**REVISION OF CITY OF
BEAVERTON STANDARD
DRAWING NO. 615
10-25-04**

**ATTENTION! THIS DRAWING REPLACES
DRAWING NO. 615, DATED 6-10-04**

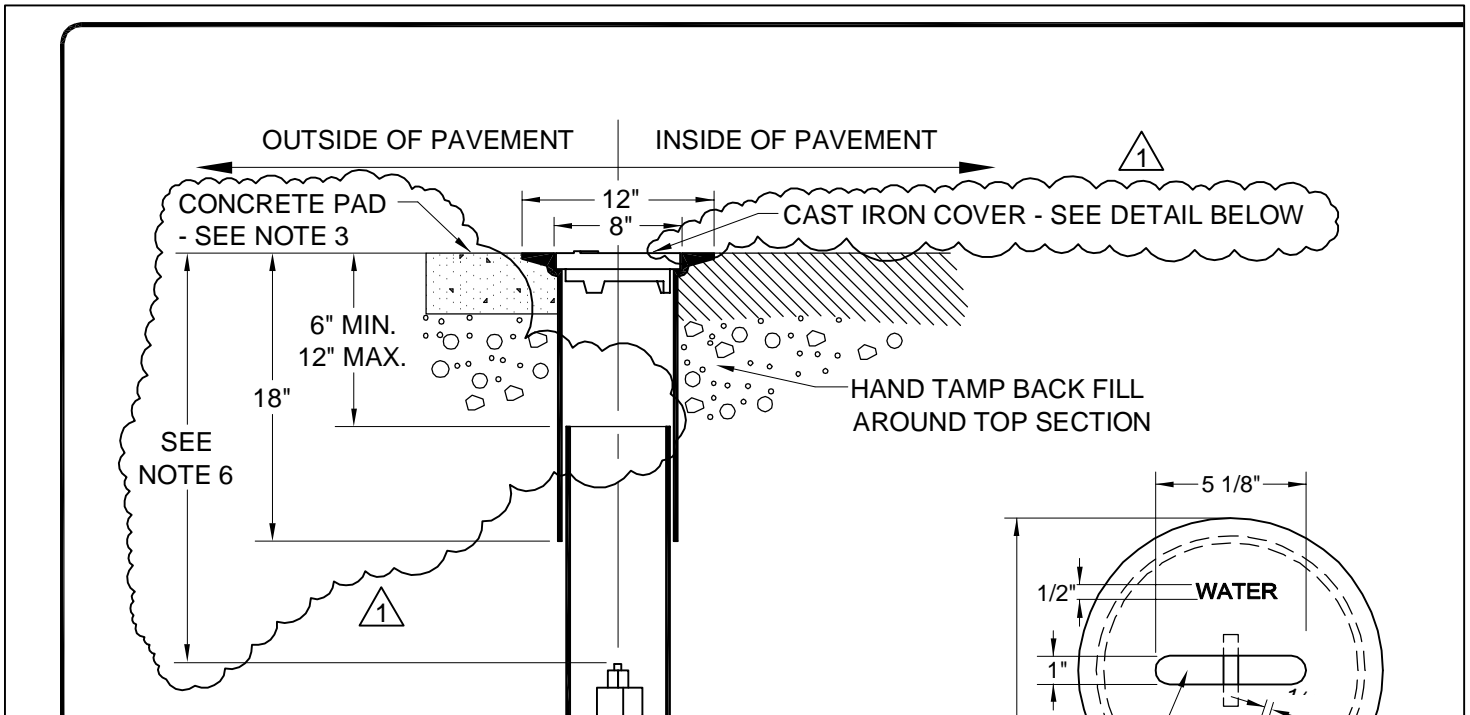
- △ 1 CHANGED DIMENSIONS THAT INDICATED THE OVERLAP OF THE TOP SECTION AND PIPE EXTENSION TO NEW DIMENSIONS THAT INDICATE DEPTH FROM FINISH GRADE TO TOP OF PIPE EXTENSION. REVISED AND RELOCATED CONCRETE PAD AND CAST IRON COVER CALL-OUTS.
